Please accept this change order proposal for the construction, delivery, and installation of cabinets, countertops, and Architectural Woodwork for The Office of Emergency Management, NYC as per drawing FSK-40 dated 11/2/98. The items included are as follows:

**CHANGE ORDER #2**

PART PLAN, ELEV. & DETAIL @ RM# 23-11

MAYORS OFFICE OF EMERGENCY MANAGEMENT

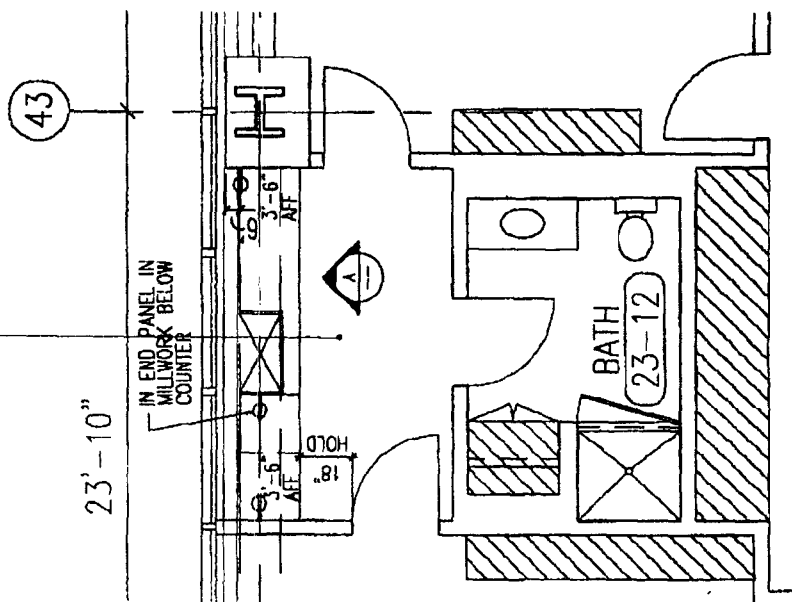
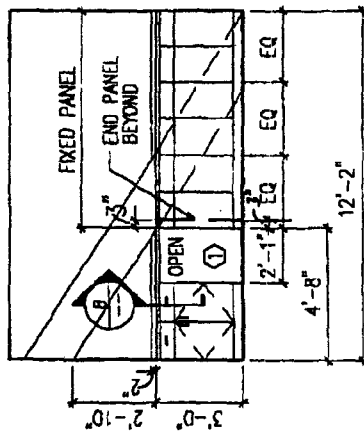
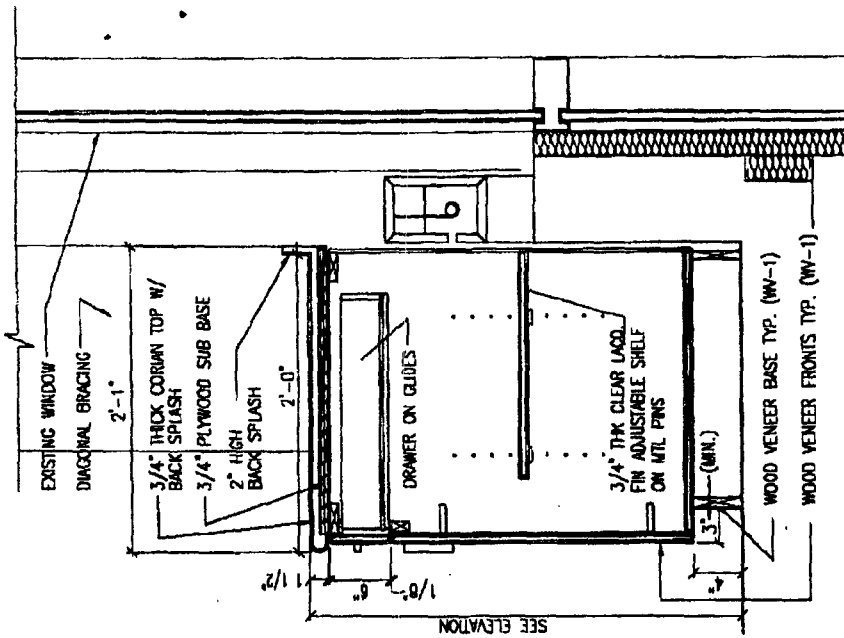
| 23-11 | 12 lin. ft. | Corian        | Countertop | 700  |
|       | 23 sq. ft.  | Custom Makore | Paneling   | 1100 |
|       | 2 lin. ft.  | Custom Makore | Lower      | 700  |

**PART REFLECTED CEILING PLAN**

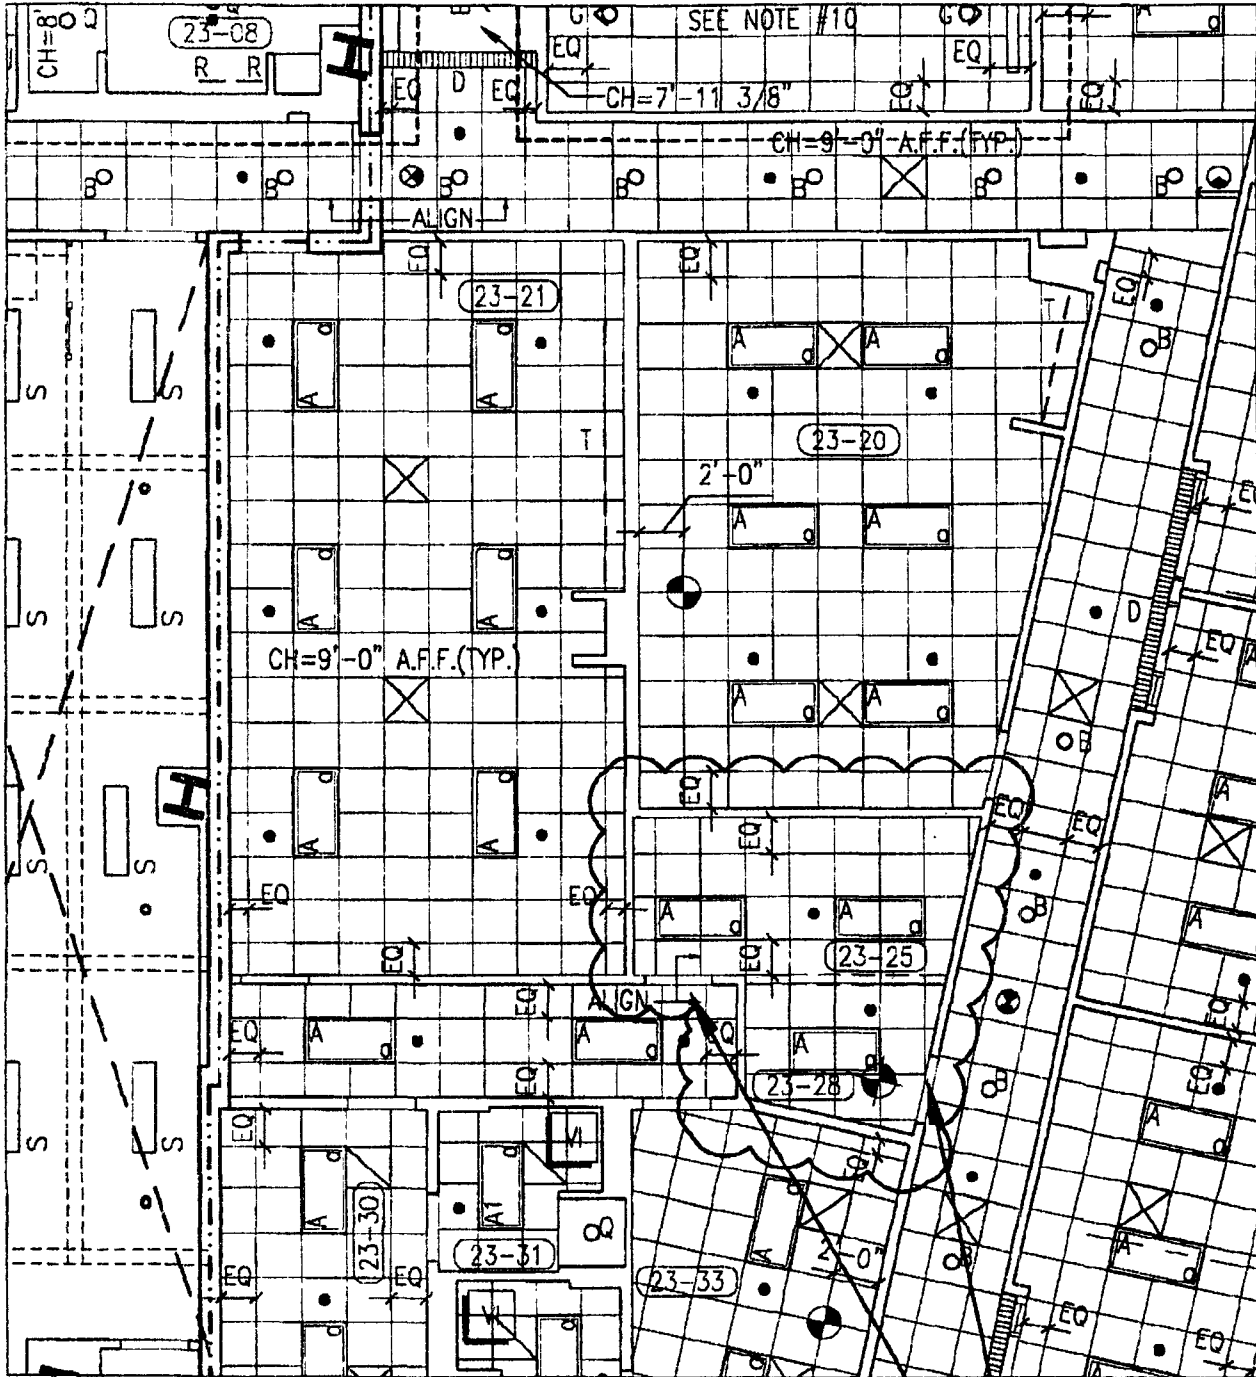
PROVIDE (2) WAY SWITCHES  
AT BOTH DOORS
